PRELIMINARY DRAINAGE REPORT

**WATERSIDE TOWNHOMES
(Waterside Condominiums Subdivision)**

JULY 2022

V3_Master Development Drainage Plan (MDDP).pdf Markup Summary

WATERSIDE TOWNHOMES
 MONUMENT, CO
 FINAL DRAINAGE REPORT
 PROPOSED CONDITIONS DRAINAGE MAP

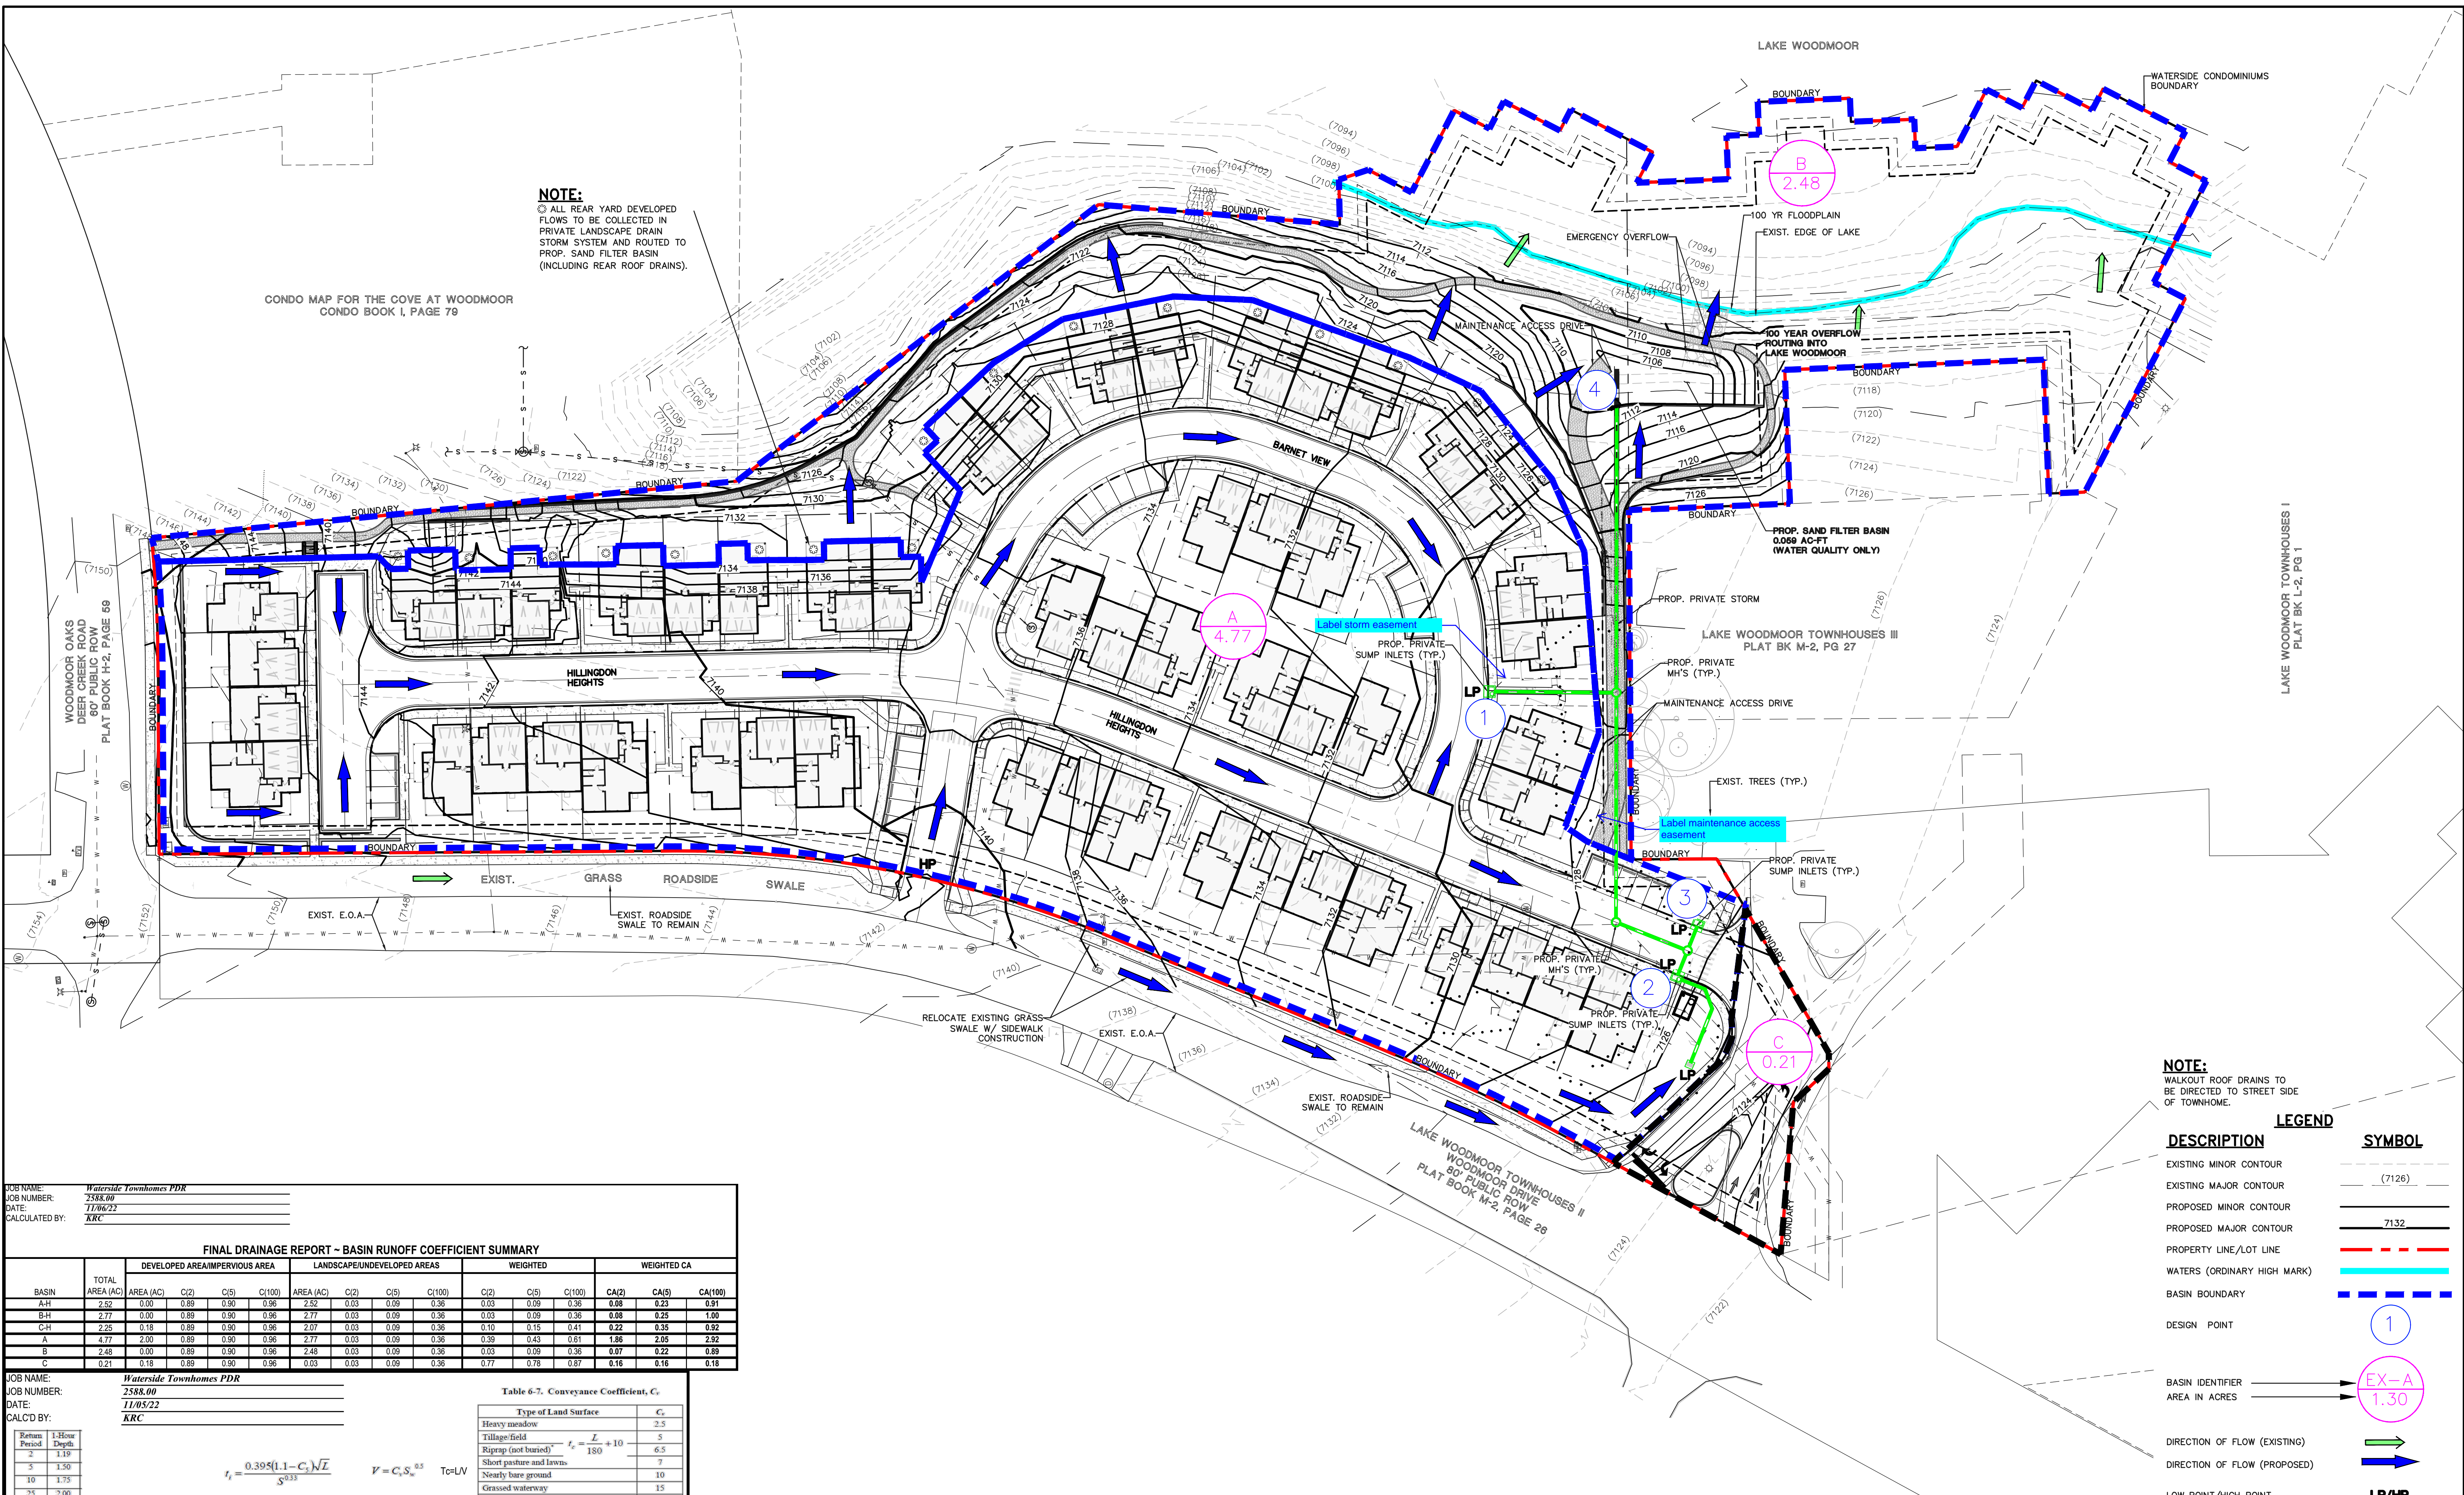
Subject: Callout
Page Label: 25
Author: CDurham
Date: 12/14/2022 5:19:57 PM
Status:
Color: ■
Layer:
Space:

Label storm easement

Subject: Callout
Page Label: 25
Author: CDurham
Date: 12/14/2022 5:20:32 PM
Status:
Color: ■
Layer:
Space:

Label maintenance access easement
